RFP Title: Site Improvements at James Ahern Park

Addendum #: 3

Issue Date: 11/8/2024

SITE IMPROVEMENTS AT JAMES AHERN PARK

38 ADD ALT #13: CORRUGATED DUGOUT ROOF: FRONT
NTS

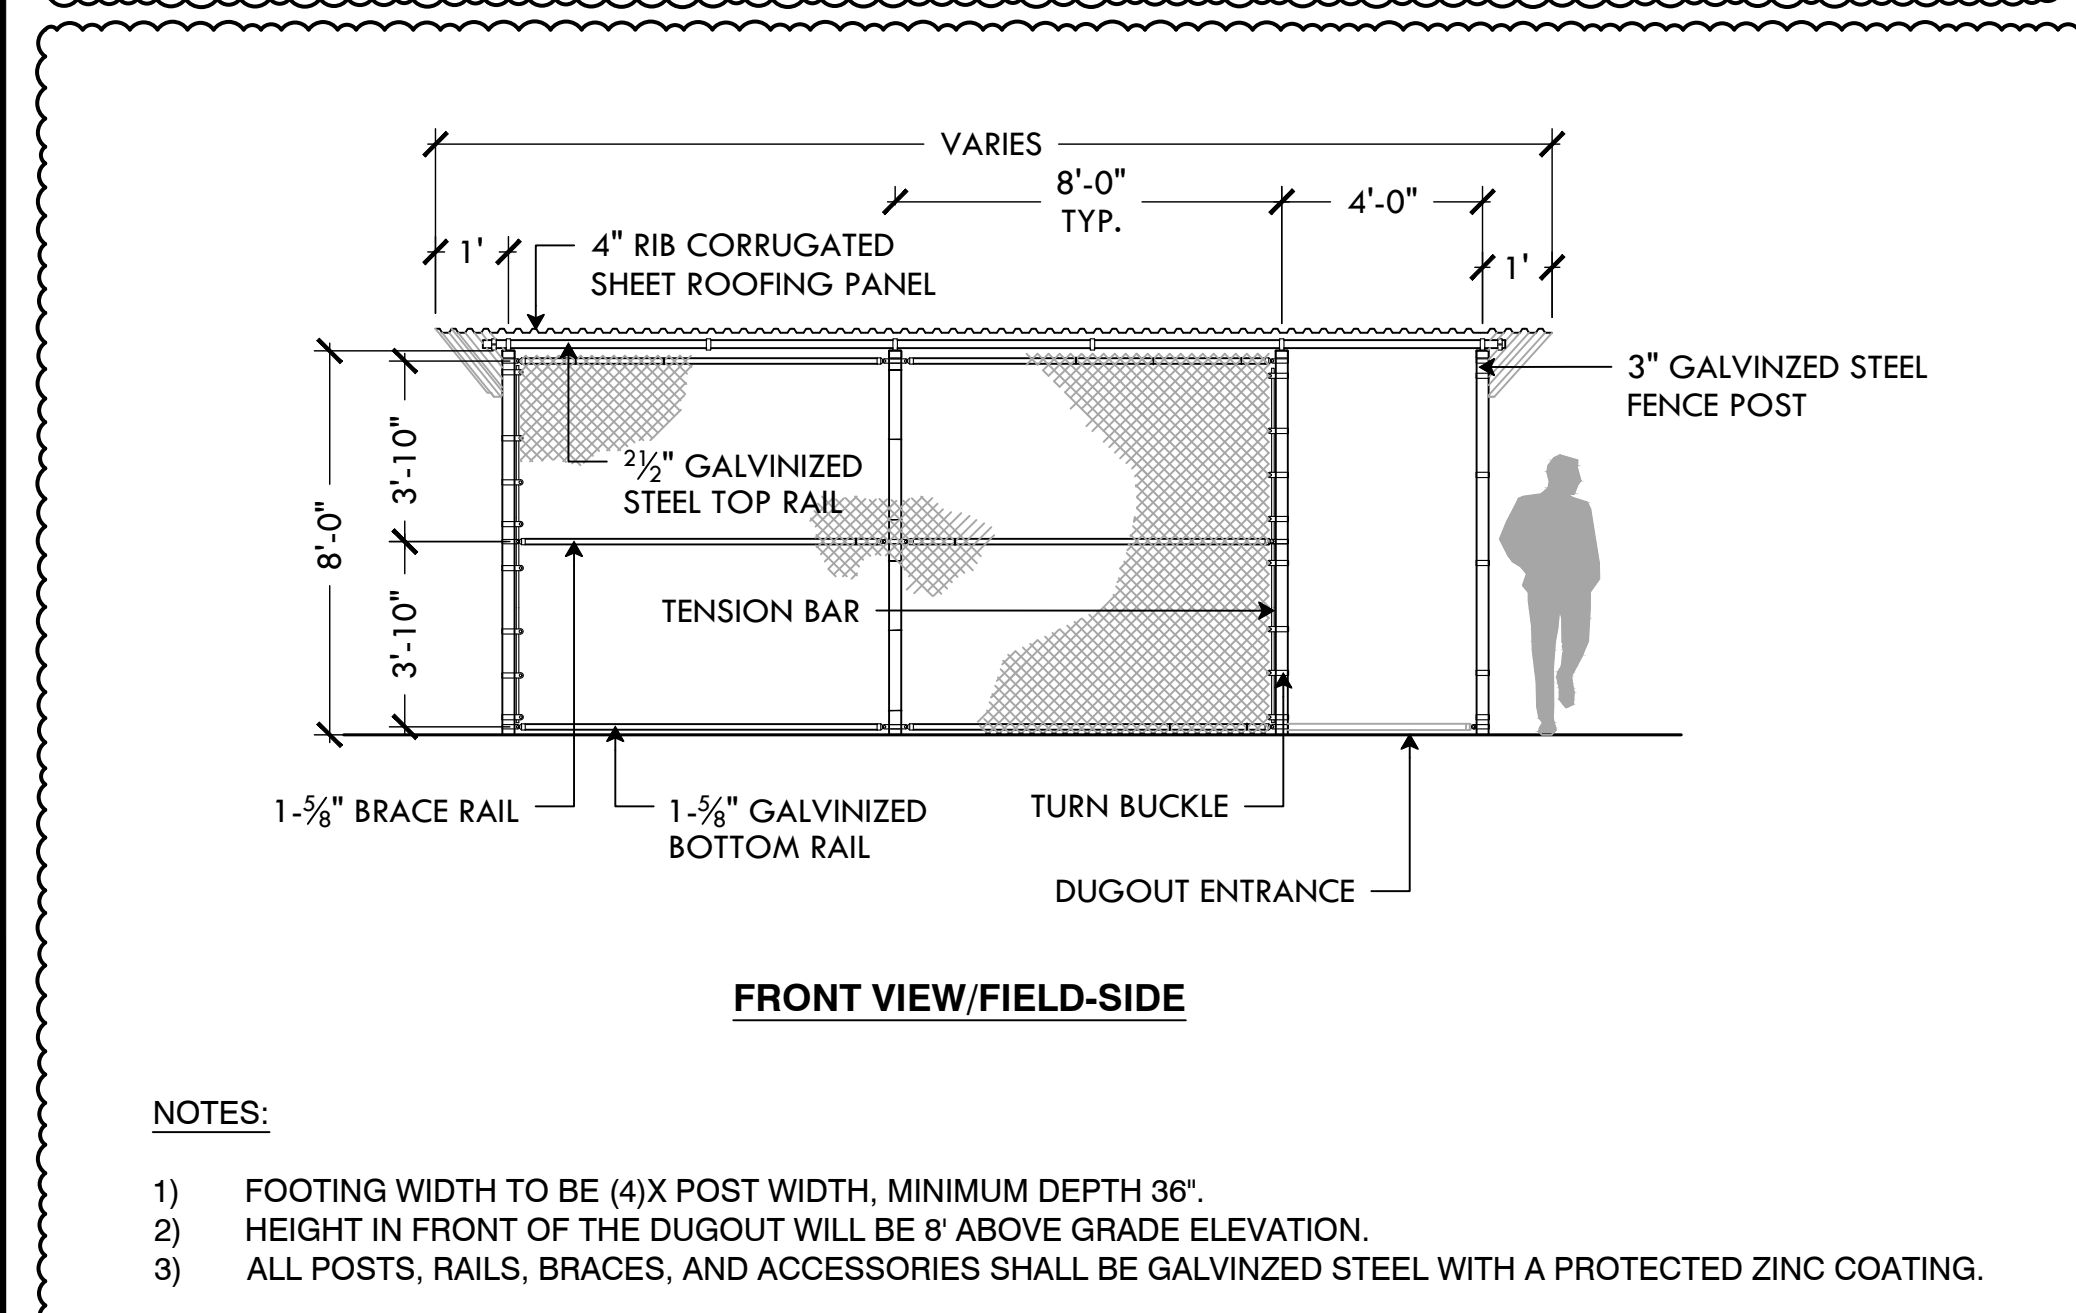
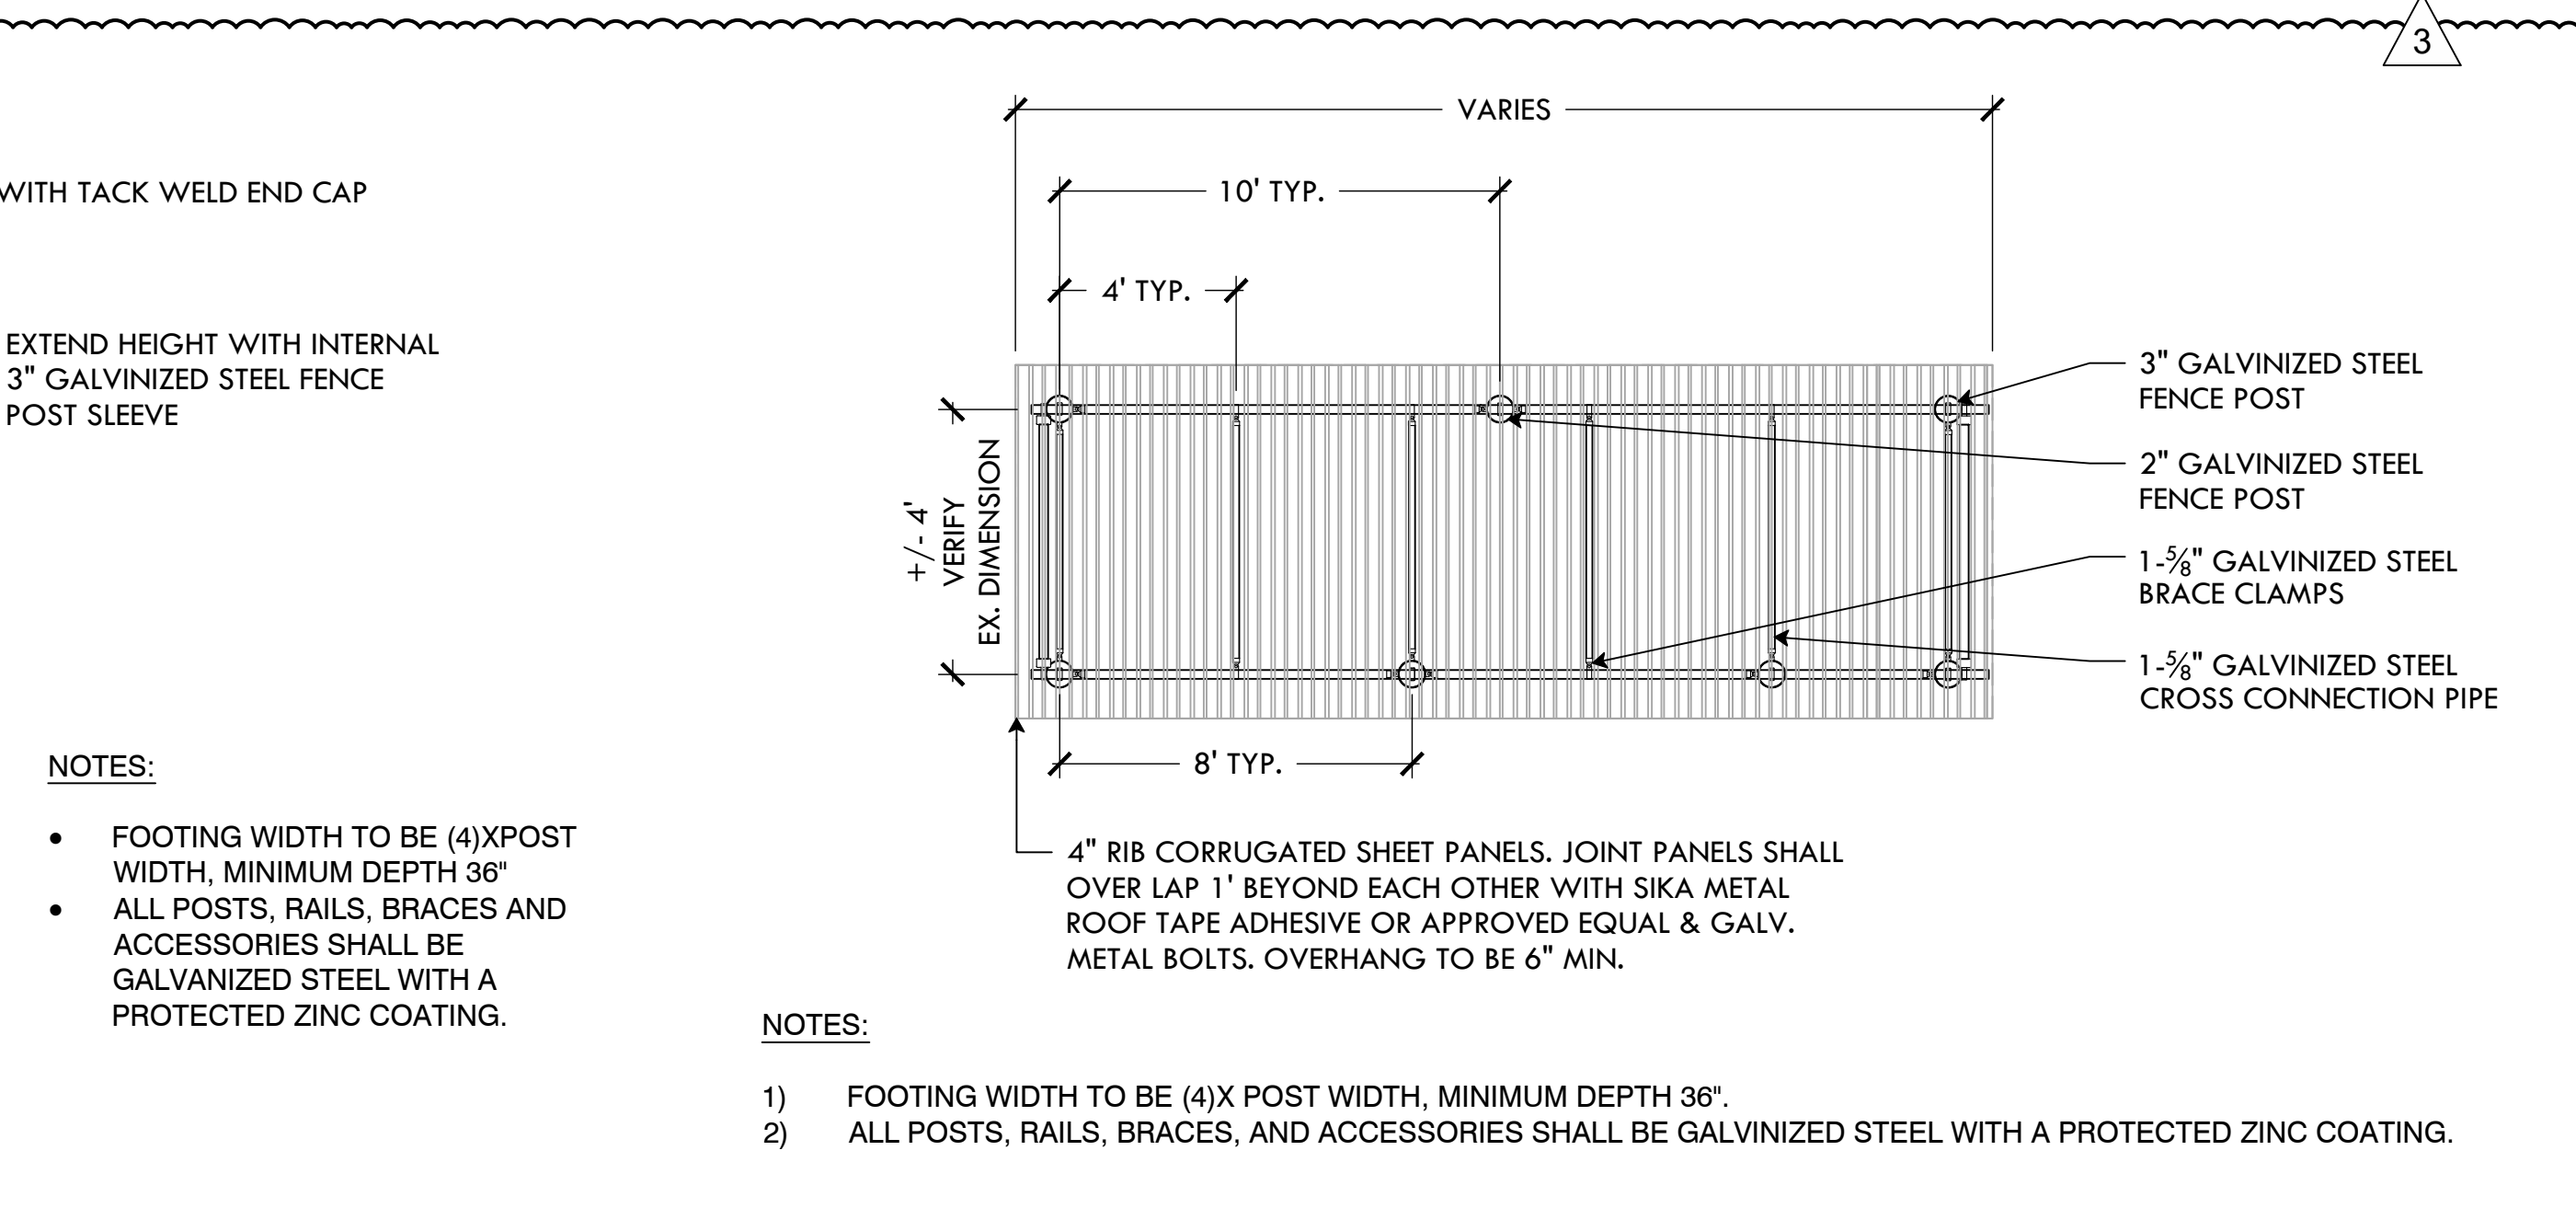
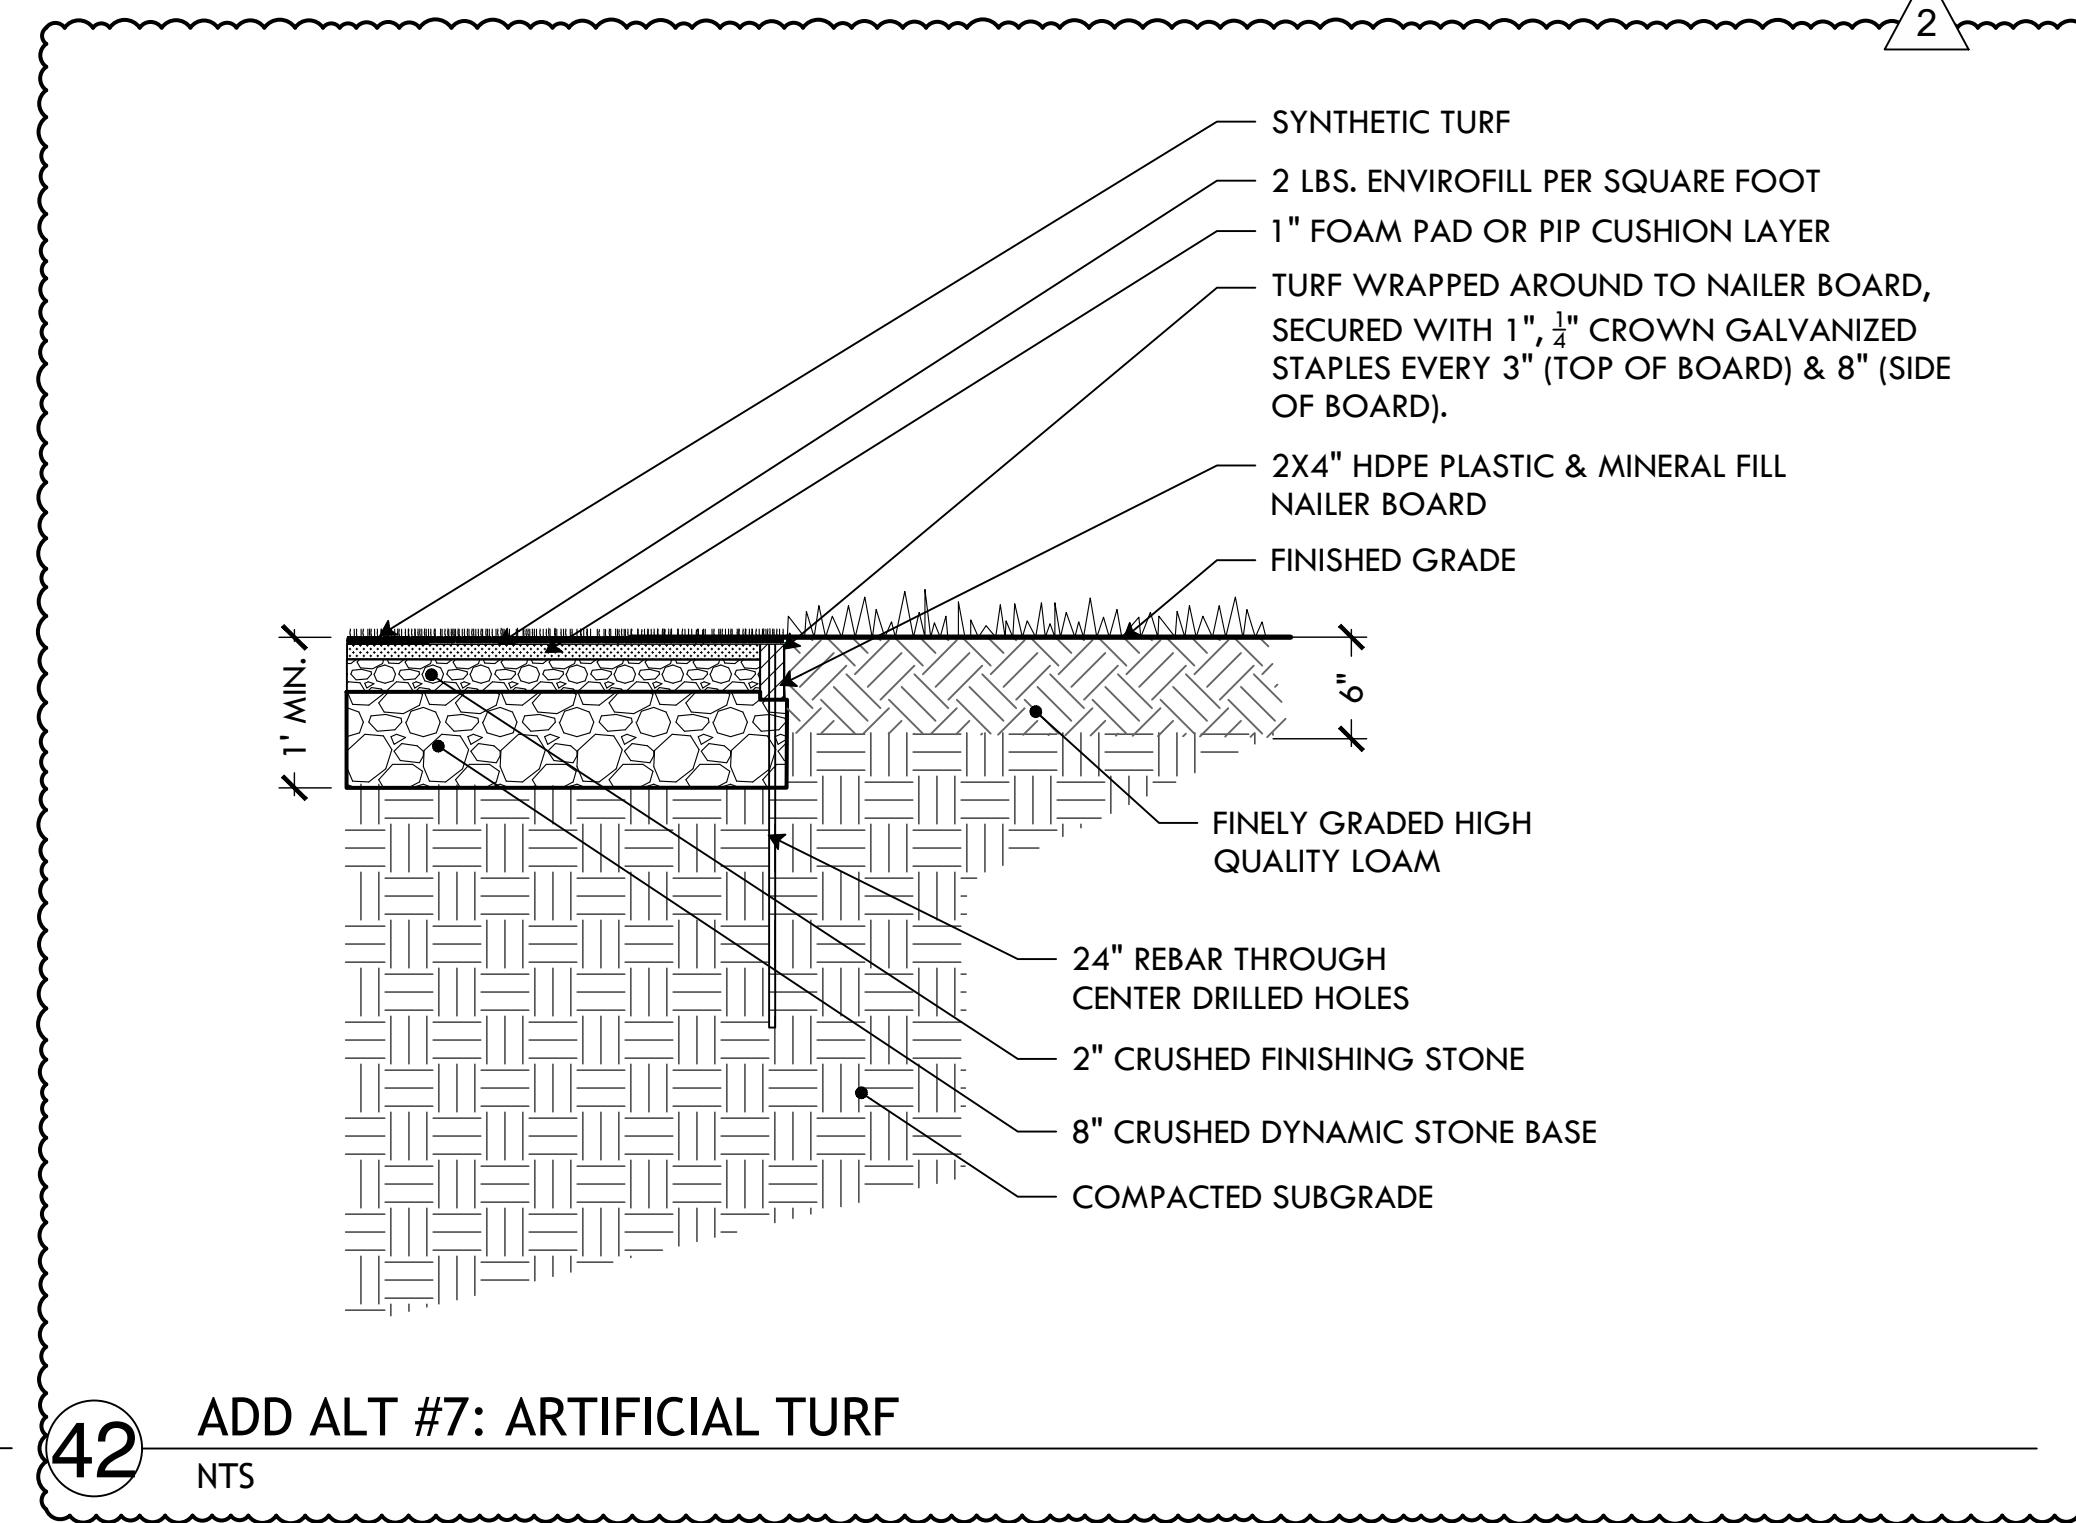
1. RFP Unit Prices – Base Bid: items #5, 6, 7 and #12 have been updated. Unit Prices - Add Alts: item #10 has been updated.
2. Add Alt #13 – **F&I Corrugated Roofs on Ex. Dugouts** – plan details have been updated for clarification.
3. Technical Specifications for the Water Park Splash Pad updated to include Vortex accessories.
4. Other drawings and details amended as shown in plan set.
